Figure 6. View of Printed Wiring Board. NOTE: White area represents printed wiring, black symbols and lines represent components and wiring of opposite side.

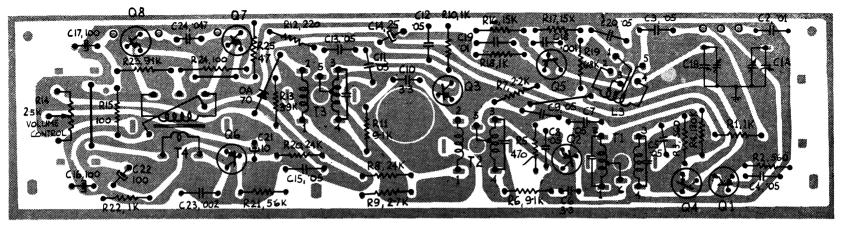
Note: In later production, R23 was changed from 9,100 ohms to 11,000 ohms and R24 from 100 ohms to 270 ohms shunted by a 350 ohms negative temperature coefficient resistor R24A.
